DEVELOPMENT REVIEW COMMITTEE

Meeting date: February 7, 2024

101 S. Ocean Blvd, Pompano Hotel – Site Plan

Request:	Major Site Plan
P&Z Number:	23-12000042
Owner:	Claridge Homes 101 Hotel LP
Project Location:	101 S. Ocean Blvd, Pompano Beach, FL
Folio Number:	494306060690
Land Use Designation:	C-Commercial
Zoning District:	B-3/AOD (Business District /Atlantic Overlay District)
Commission District:	1 (Andrea McGee)
Agent:	Andrew J. Schein (954-617-8919 aschein@lochrielaw.com)
Project Planner:	Lauren Gratzner (954-545-7792 Lauren.Gratzer@copbfl.com)

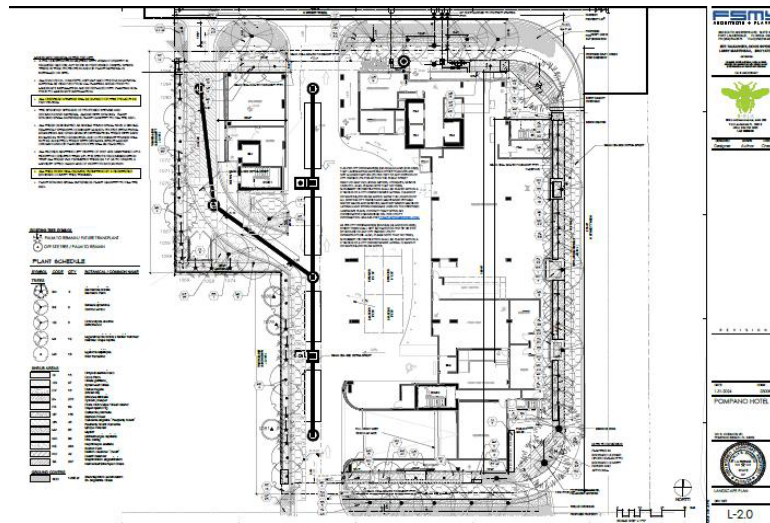
1. Provide evidence and note on plans and in narrative that all overhead utilities will be buried for this project as per 155.5509.

RESPONSE: Overhead utility note was provided on sheet L-2.0. A box was added to highlight utility note. See image below highlighted in yellow.

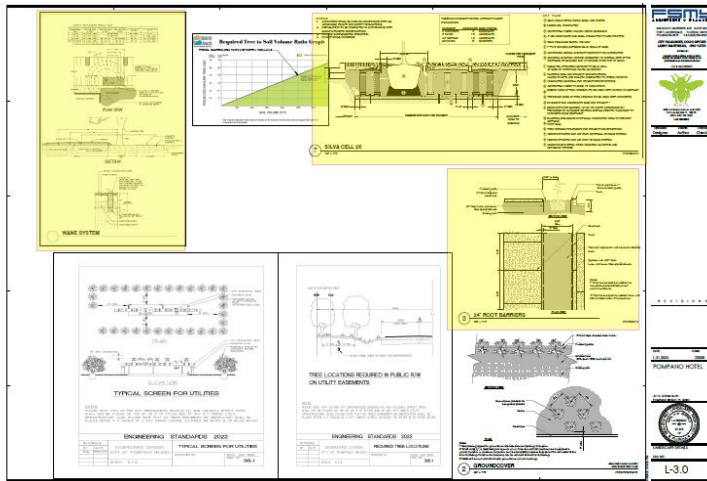
5. As per 155.5203.B.2.ii. Based on the height of the building half of all required canopy trees are to be 16' tall and palms to be 22' OA, please adjust. Provide evidence of availability for proposed species at those heights. Redbay, Jamaican capers, and Elaeocarpus as they are not known to be available.

RESPONSE: The tree species have been amended. As shown on Sheet L-2.1, the canopy trees will be a minimum of 16' in height at the time of planting and the palms will be a minimum of 22' in height at the time of planting. www.Plantant.com and Plant finder utilized for tree availability.
